**SOLICITATION AMENDMENT
MODIFICATION DE L'INVITATION**

Title - Sujet Kentville Winery	
Solicitation No. - N° de l'invitation EB144-182595/A	Amendment No. - N° modif. 002
Client Reference No. - N° de référence du client EB144-18-2595	Date 2018-02-23
GETS Reference No. - N° de référence de SEAG PW-\$PWA-121-5719	
File No. - N° de dossier PWA-7-78135 (121)	CCC No./N° CCC - FMS No./N° VME
Solicitation Closes - L'invitation prend fin at - à 02:00 PM on - le 2018-03-01	Time Zone Fuseau horaire Atlantic Standard Time AST
F.O.B. - F.A.B. Plant-Usine: <input type="checkbox"/> Destination: <input checked="" type="checkbox"/> Other-Autre: <input type="checkbox"/>	
Address Enquiries to: - Adresser toutes questions à: Russell (PWA), Alex	Buyer Id - Id de l'acheteur pwa121
Telephone No. - N° de téléphone (902) 401-8180 ()	FAX No. - N° de FAX (902) 496-5016
Destination - of Goods, Services, and Construction: Destination - des biens, services et construction:

La modification 002 vise à indiquer ce qui suit :

WA-1

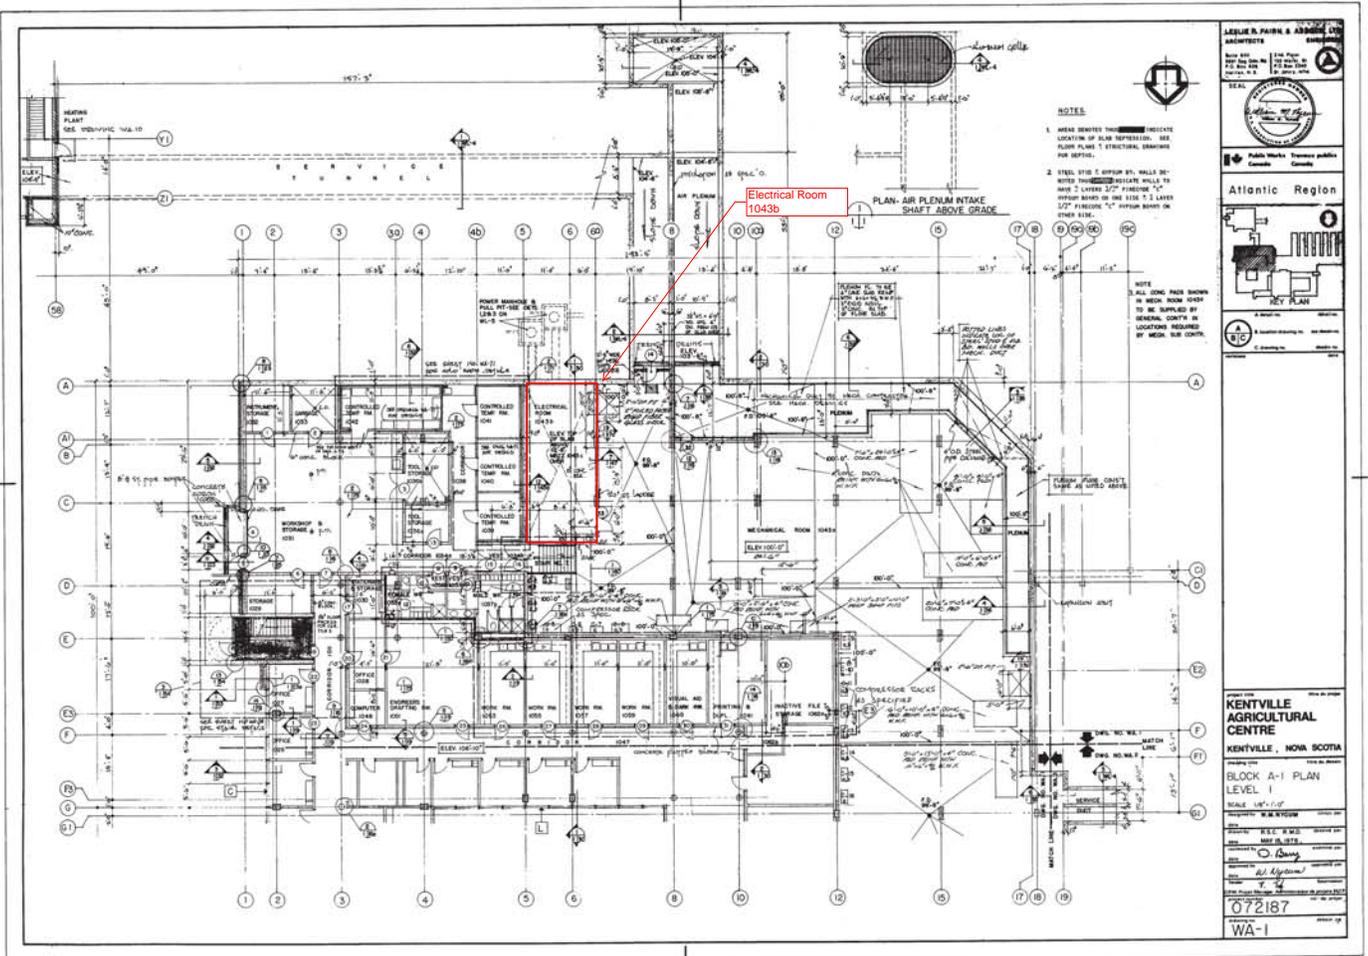
Q12 Where is the Room 1043B switchboard section 15 & 12 ? These boards are feeding Panels EM11 & 2U but are not shown on drawings?

A12 Refer to attached sketch.
